**Regarding: 03V-309 Expansion of Recall
 1999 through 2001 Model Year Yamaha XV1600
 Transmission Factory Modification Campaign**

Technical BULLETIN

1999~2001 XV16 MODELS FACTORY MODIFICATION CAMPAIGN

Main Shaft Modification:

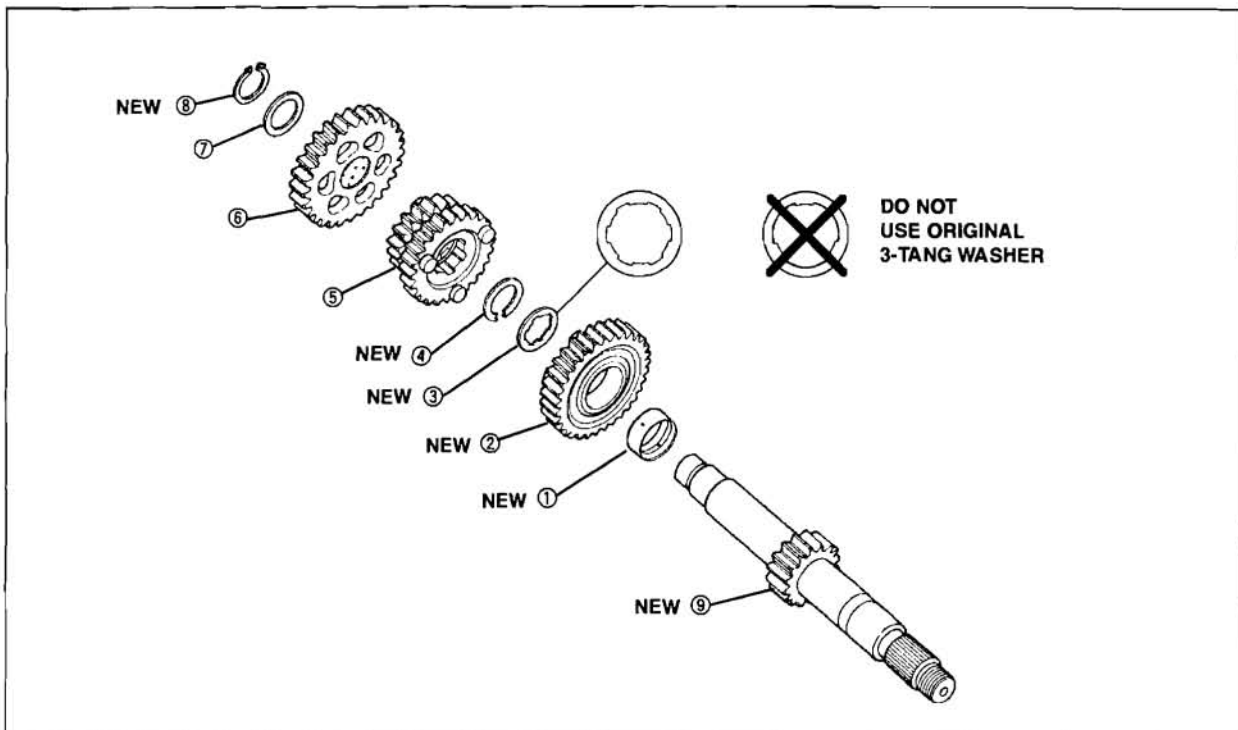
- Completely disassemble the main shaft. The Washer ⑦, 5th Pinion Gear ⑥, and 2nd/3rd Pinion Gear ⑤ will be reused.
- Install the components on the new-type Main Shaft ⑨ in the following order. Lubricate all components with engine oil. Be sure circlips are installed with the sharp edge of the inner diameter facing away from the mating washer.

- ① Collar – NEW
- ② 4th Pinion Gear – NEW
- ③ Washer – NEW
- ④ Circlip – NEW
- ⑤ 2nd/3rd Pinion Gear – Reuse original part
- ⑥ 5th Pinion Gear – Reuse original part
- ⑦ Washer – Reuse original part
- ⑧ Circlip – NEW

Be sure to use all of the new parts in the kit. Otherwise, the transmission can still fail. Be sure that you are installing the new washer ③. It is thicker than the original and can be easily identified by its six tangs on the inner diameter instead of the three on the original washer.

Drive Shaft Modification:

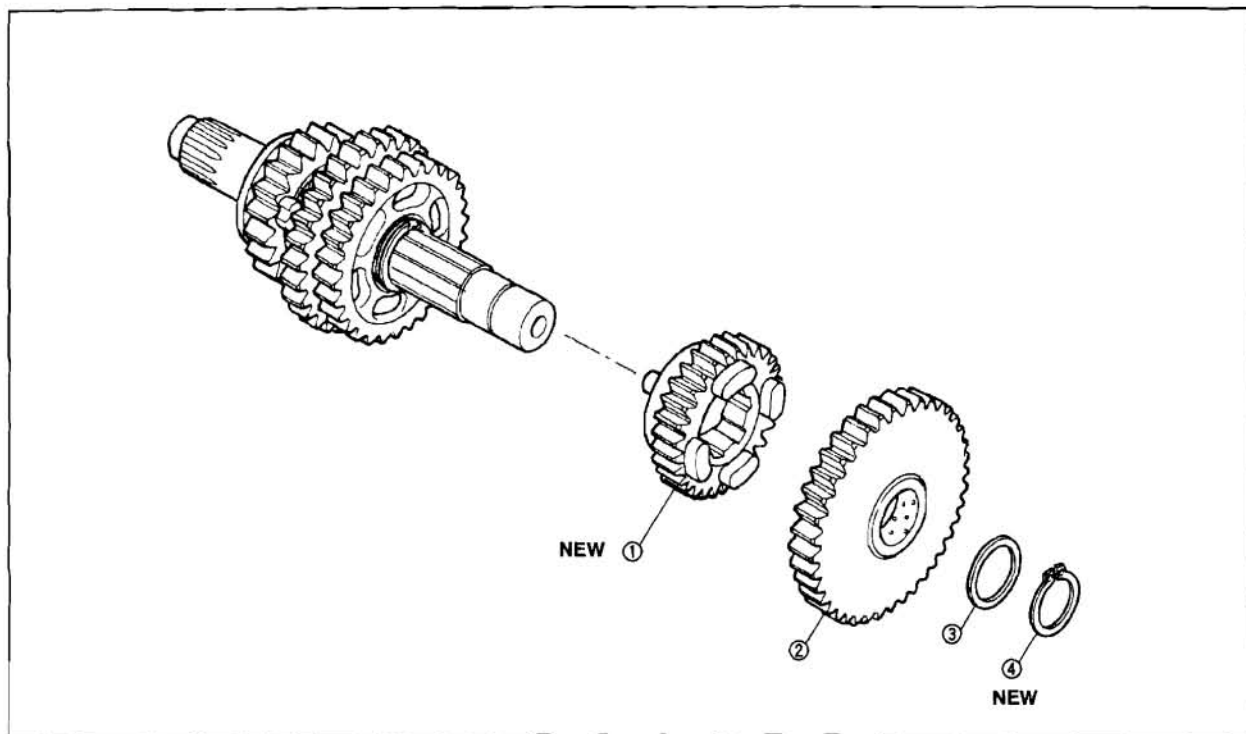
- Remove the circlip and washer from the Drive Shaft, then remove the 1st Wheel Gear and the 4th Wheel Gear. Do not disassemble the rest of the components on the shaft.
- Install the components on the original Drive Shaft in the following order. Lubricate all components with engine oil. Be sure the circlip is installed with the sharp edge of the inner diameter facing away from the mating washer.

- ① 4th Wheel Gear – NEW
- ② 1st Wheel Gear – Reuse original part
- ③ Washer – Reuse original part
- ④ Circlip – NEW

Be sure to use all of the new parts in the kit. Otherwise, the transmission can still fail.
